Addendum 128 – Regulation No. 129

Amendment 1

Uniform provisions concerning the approval of Enhanced Child Restraint Systems used on board of motor vehicles (ECRS)

Appendix 3, the figure, amend to read:

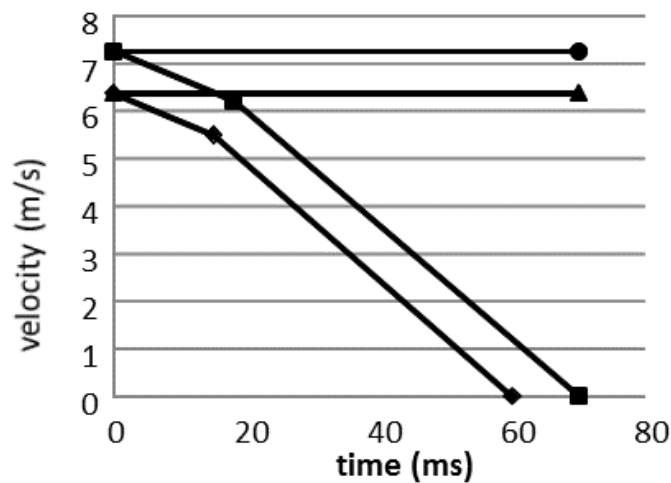
- ◆ Lower corridor of relative velocity
- Upper corridor of relative velocity
- ▲ Lower corridor of door ground velocity(door moving test at t_0 only)
- Upper corridor of door ground velocity (door moving test at t_0 only)
